## Product Change Notice (PCN)

PCN Number: **PCN-0451150R-01**

Product(s) Affected: PJ-037AH

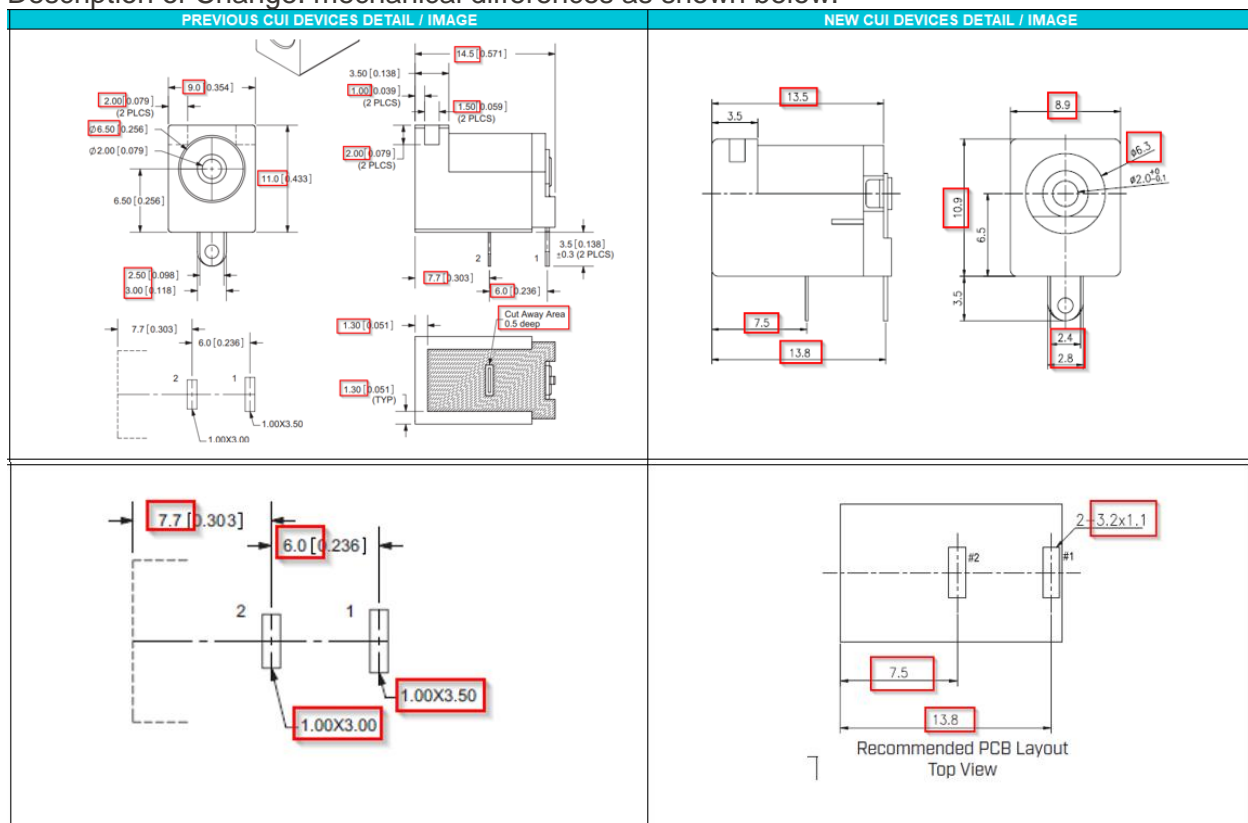
Description of Change: mechanical differences as shown below:

<table border="1" style="width: 100%; border-collapse: collapse;"> <thead> <tr> <th></th> <th>MATERIAL</th> <th>PLATING</th> </tr> </thead> <tbody> <tr> <td>center pin</td> <td>copper</td> <td>nickel</td> </tr> <tr> <td>terminal 1</td> <td>brass</td> <td>silver</td> </tr> <tr> <td>terminal 2</td> <td>copper alloy</td> <td>silver</td> </tr> <tr> <td>plastic</td> <td>PBT</td> <td></td> </tr> </tbody> </table>		MATERIAL	PLATING	center pin	copper	nickel	terminal 1	brass	silver	terminal 2	copper alloy	silver	plastic	PBT		<table border="1" style="width: 100%; border-collapse: collapse;"> <thead> <tr> <th>DESCRIPTION</th> <th>MATERIAL</th> <th>PLATING/COLOR</th> </tr> </thead> <tbody> <tr> <td>center pin</td> <td>copper alloy</td> <td>nickel</td> </tr> <tr> <td>terminal 1</td> <td>brass t=0.3 mm</td> <td>nickel-silver</td> </tr> <tr> <td>terminal 2</td> <td>phosphor bronze t=0.3 mm</td> <td>nickel-silver</td> </tr> <tr> <td>housing</td> <td>PBT [UL94V-0]</td> <td>black</td> </tr> <tr> <td>cover</td> <td>PBT [UL94V-0]</td> <td>black</td> </tr> </tbody> </table>	DESCRIPTION	MATERIAL	PLATING/COLOR	center pin	copper alloy	nickel	terminal 1	brass t=0.3 mm	nickel-silver	terminal 2	phosphor bronze t=0.3 mm	nickel-silver	housing	PBT [UL94V-0]	black	cover	PBT [UL94V-0]	black

MATERIAL	PLATING																																
center pin	copper	nickel																																
terminal 1	brass	silver																																
terminal 2	copper alloy	silver																																
plastic	PBT																																	
DESCRIPTION	MATERIAL	PLATING/COLOR																																
center pin	copper alloy	nickel																																
terminal 1	brass t=0.3 mm	nickel-silver																																
terminal 2	phosphor bronze t=0.3 mm	nickel-silver																																
housing	PBT [UL94V-0]	black																																
cover	PBT [UL94V-0]	black

Insertion/extraction force adjusted to 0.3 ~ 2.0 kg
